APPLICATION NO.	FILING DATE	FIRST NAMED INVENTOR	ATTORNEY DOCKET NO.	CONFIRMATION NO.
10/740,465	12/22/2003	Jung Sang Baek	0465-1062P	3623
2292 7590 11/30/2007 BIRCH STEWART KOLASCH & BIRCH PO BOX 747 FALLS CHURCH, VA 22040-0747			EXAMINER MOON, SEOKYUN	
			ART UNIT 2629	PAPER NUMBER
			NOTIFICATION DATE 11/30/2007	DELIVERY MODE ELECTRONIC

Office Action Summary	Application No. 10/740,465	Applicant(s) BAEK ET AL.	
	Examiner Seokyun Moon	Art Unit 2629

DETAILED ACTION

Drawing 1

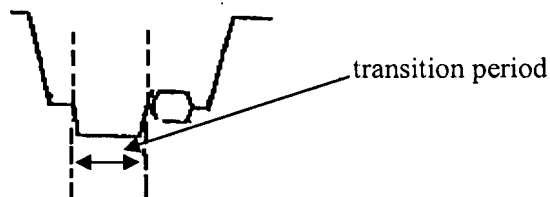
The Applicants pointed out that neither the AAPA nor the base reference to Park discloses or suggests the previously presented claim limitation, "*first skipping data latch during a first transition period of the video signal*" and "*second skipping data latch during a second transition period of the video signal*" [pg 10 lines 7-10]. Examiner respectfully disagrees. Examiner respectfully submits that the Applicants have failed to explain how the Examiner's interpretation regarding the AAPA is not reasonable or proper with respect to the disclosed claim limitation. As shown on drawing 1 provided below (which is equivalent to figure 2 of the instant application), the AAPA teaches the video signal having a transition period (note that since the value of the video signal is changed during the period indicated below, it would be reasonable to interpret the period as a transition period).

Furthermore, as explained in the previous Office Action, since the signal, "HSY", goes to a low level during the transition period, data latching operation of the time controller is paused during the transition period, and thus the AAPA teaches the disclosed claim limitation, "*first skipping data latch during a first transition period of the video signal*" and "*second skipping data latch during a second transition period of the video signal*".

The Applicants further pointed out that none of the cited references teaches the amended claim limitation, "*a clock enable signal disabled at the first transition period of the video signal*" [pg 10 lines 16-18]. Examiner respectfully disagrees. Examiner respectfully submits that it would be reasonable to construe any one of the signals, "HSY", "HSP", and "SSP" as a clock enable signal since all of the signals are periodic and thus all of the signals are clock signals having a low frequency. Furthermore, since all of the signals are related to timing of driving operation of the display, such as determining a timing of starting a source signal, synchronizing a timing of driving a video signal to a clock signal, etc, all of the signals are related to enabling driving operation of the display. Therefore, it would be reasonable to interpret any one of the signals, "HSY", "HSP", and "SSP" as a clock enable signal.
